9.4 Air Conditioning, Heating, Cooling and Ventilating Systems

The information in this section of the reference ABWR DCD, including all subsections, tables, and figures is incorporated by reference with the following departures and supplements.

Figure 9.4-2c Turbine Building Electrical Equipment Areas (EEA) HVAC System Diagram

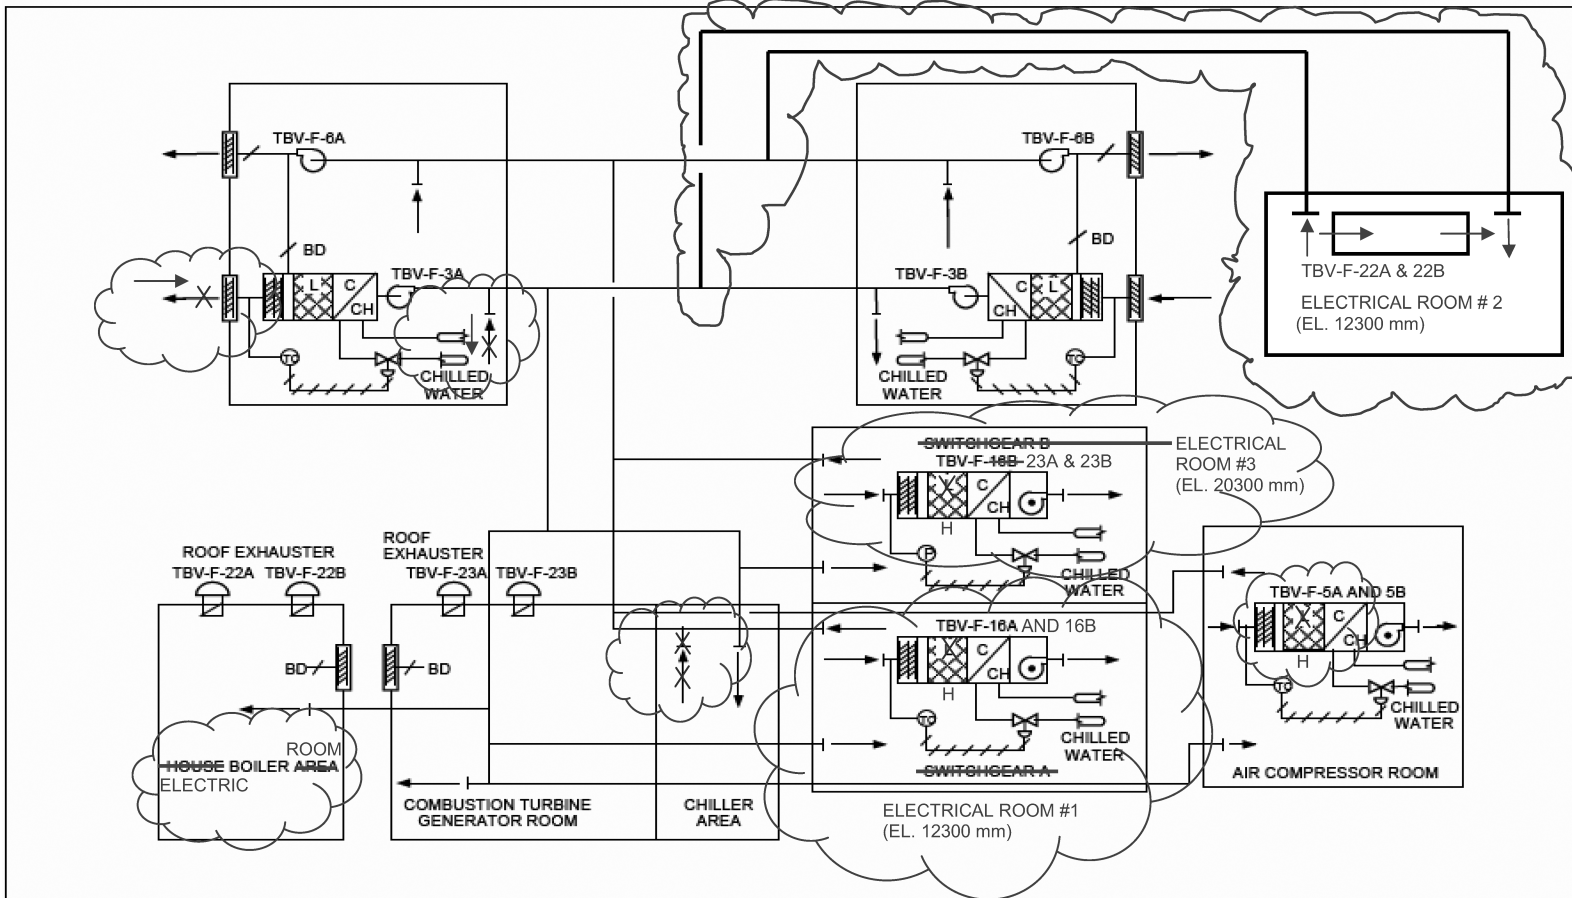
STD DEP 9.4-4 (Tables 9.4-3, 9.4-5, 9.4-5a, 9.4-5b, 9.4-5c, and 9.4-5d), (Figures 9.4-2a, 9.4-2b Sheet 2, and 9.4-2c)

The ~~E/B~~ EEA HVAC schematic diagram is shown on Figure 9.4-2c.

STD DEP 9.4-4

The Electrical ~~Building~~ Equipment area HVAC System is provided with two 100% capacity air supply fans and two 100% capacity exhaust fans.

The air supply fan draws outside air through louvers, control dampers, low efficiency filters, electrical heating coils, and chilled water coils, and discharges air directly into the ~~switchgear~~ electrical rooms, chiller, combustion turbine generator, ~~house~~ electric boiler room and air compressor rooms. Return air ~~Ductwork~~ ductwork and ~~bypass dampers are~~ is provided to allow recirculation of air from the ~~switchgear~~ electrical rooms and ~~chiller rooms~~ air compressor room.

The ~~E/B~~ EEA HVAC system maintains the Electrical ~~Building~~ Equipment Areas at a positive pressure with respect to atmosphere.
